February 18, 1992
Fort St. Vrain
Unit No. 1
P-92064

**SUBJECT: PSC RESPONSE TO NRC REQUEST FOR ADDITIONAL
INFORMATION ON THE FORT ST. VRAIN PROPOSED
DECOMMISSIONING PLAN - QUESTIONS NO. 9, 12, & 14**

**PSC RESPONSE
TO NRC QUESTIONS NO. 9, 12, & 14**

Figure 9.2-1 Rotary Work Platform

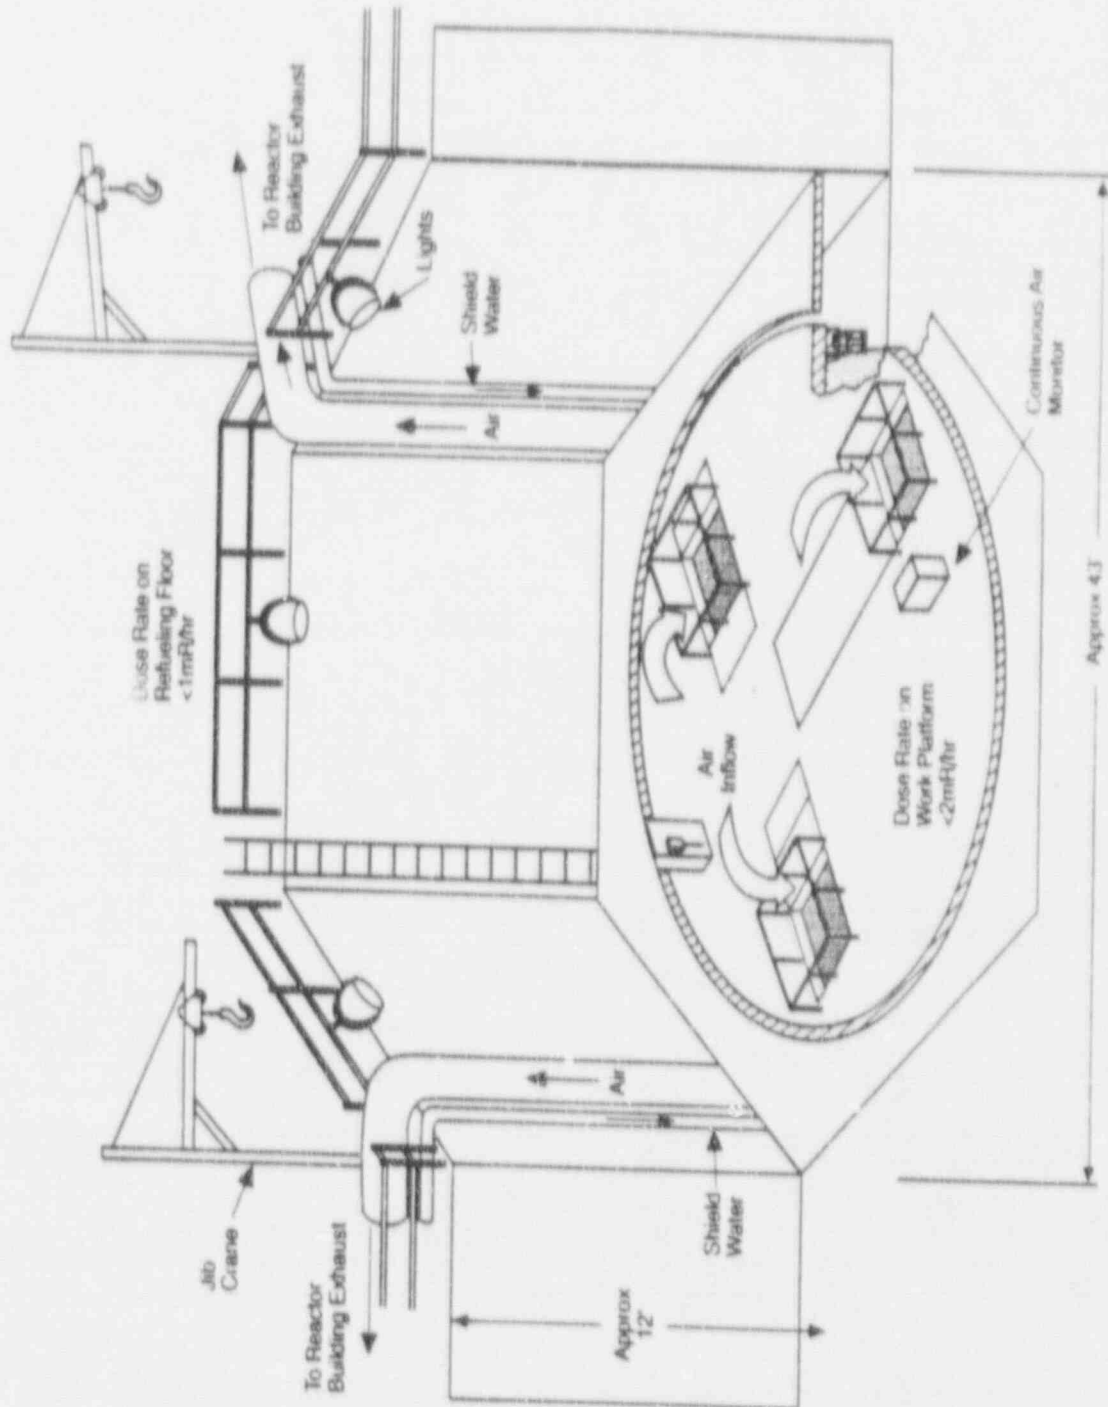
"Provide a safety analysis of procedures being developed to minimize personnel exposure. What maximum radiation levels are expected at worker locations during removal of radioactive components? Neither the April 26, 1991 response nor the July 1 revision to the Decommissioning Plan provide this information."

The arrangement of the work area that will be typically used for removal of all types of graphite blocks was provided in response to NRC RAI Question No. 13 (Figure 13-4) and is provided again in Figure 9.2-1 for reference. The PCRV will have been filled with shield water to a level approximately 4 feet above the graphite blocks, but below the top of the PCRV liner. The Work Platform will have been installed on the ledge at the bottom of the hex opening in the PCRV. The Work Platform will be designed with the capability of rotating to provide access to all areas of the core. It will have three access openings to allow insertion and removal of tools and components. This will permit up to three operations to proceed in parallel. A floor will be installed between the platform and the walls of the PCRV at the level of the Work Platform. There will be three jib cranes installed on the refueling floor level to service the access openings in the platform. The Reactor Building crane will also be available to service the platform and the remainder of the refueling floor area. A ventilation system will be installed to provide control of airborne contamination, including tritium. Air will be drawn from the refueling floor to the Work Platform, down through the access openings in the platform, and then exhausted to the Reactor Building Ventilation System (System 73). The discharges from the Reactor Building Ventilation System will be monitored in accordance with the FSV Offsite Dose Calculation Manual (ODCM) [11]. The airflow from uncontaminated areas to contaminated areas through the Work Platform will minimize personnel exposure to airborne contamination.

Figure 9.3-1 Core Barrel

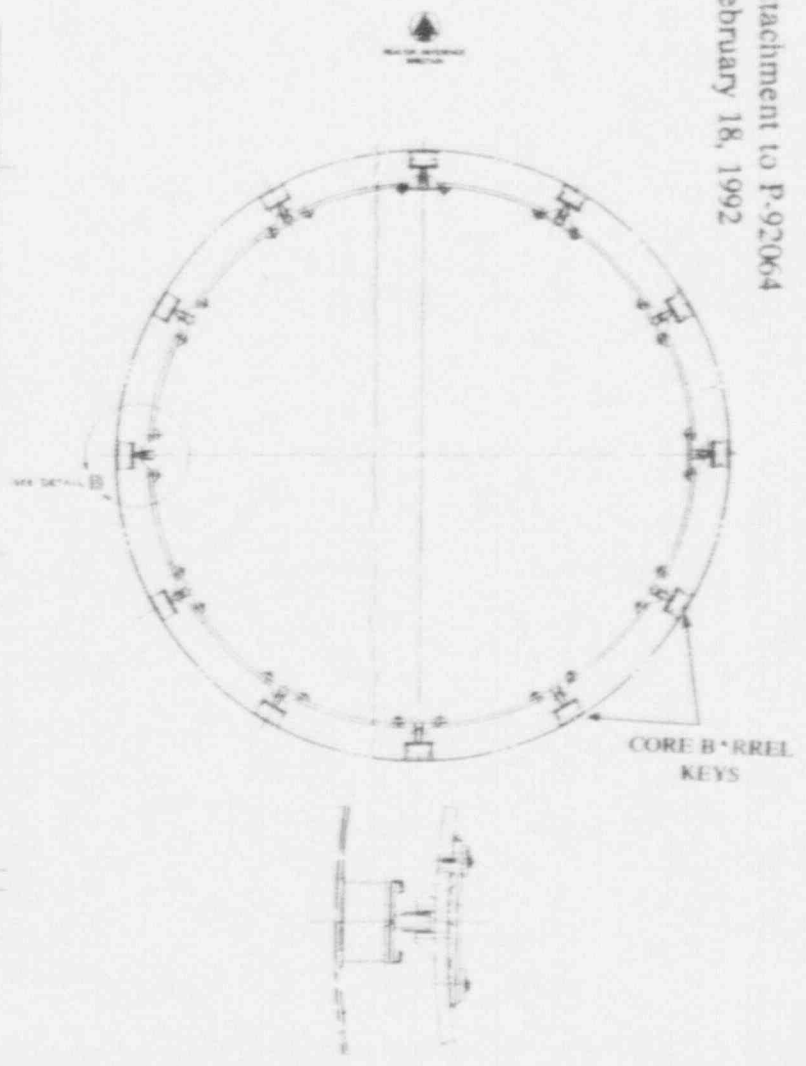
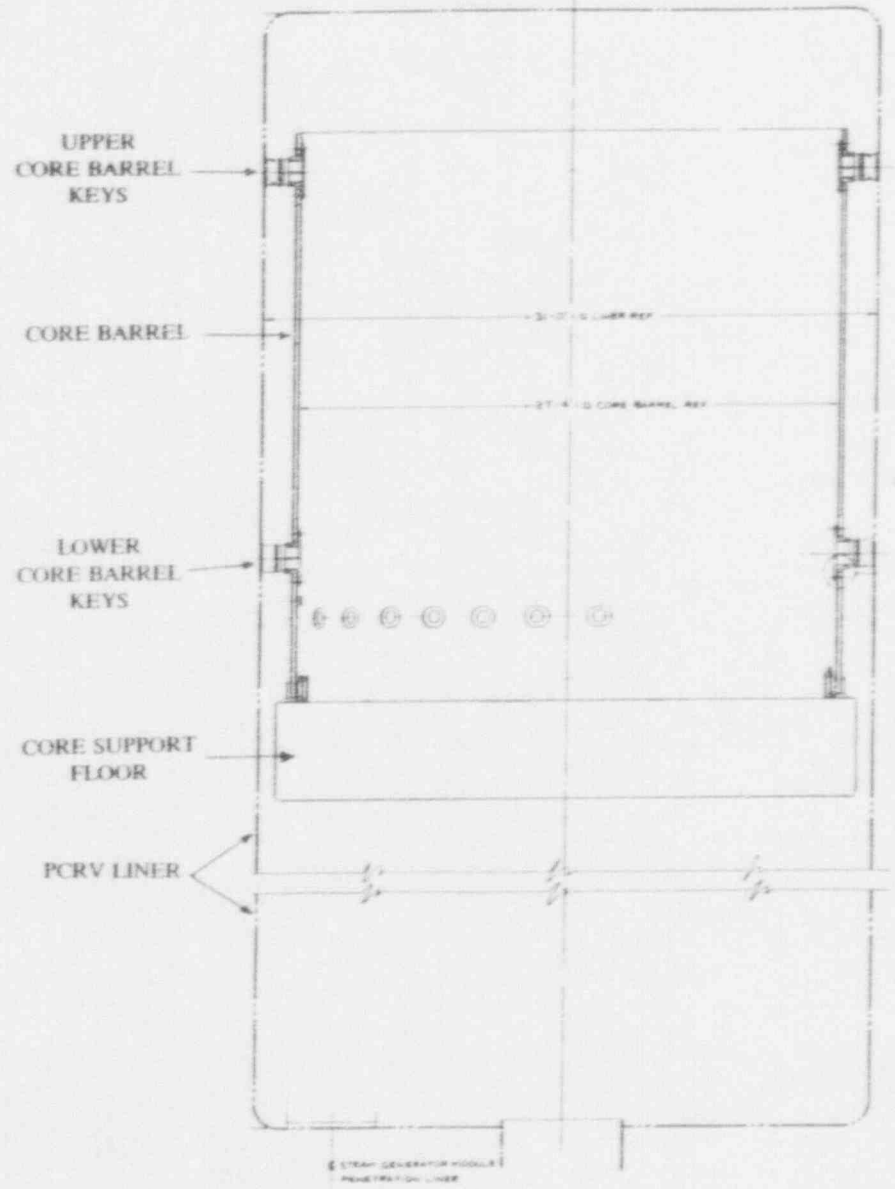
"The July 1, 1991 revision selects a thermal cutting method for core barrel removal. Provide procedures and related safety analysis for minimization of occupational exposure to personnel."

The core barrel, Figure 9.3-1, is a steel cylinder approximately 27 feet 4 inches inside diameter and 29 feet high. Its thickness steps from 2.25 inches thick at the top to 2.75 inches at the bottom. The core barrel has 12 upper outer keys and 12 lower outer keys which center the core barrel to the PCRV liner. The lower three feet of both the inside and outside surface of the core barrel is insulated. In addition, there are seven thermocouple penetrations located about four feet above the bottom of the core barrel that are between the PCRV and the core barrel.

1. Rigging the core barrel sections for removal.
2. Making horizontal and vertical cuts in the core barrel to segment it into sections suitable for handling.
3. Removing the core barrel segments out of the PCRV.
4. Progressively removing the outer keys and thermocouple expansion joint assembly that is between the PCRV liner and the core barrel.
(See the core barrel key detail on Figure 9.3-1.)
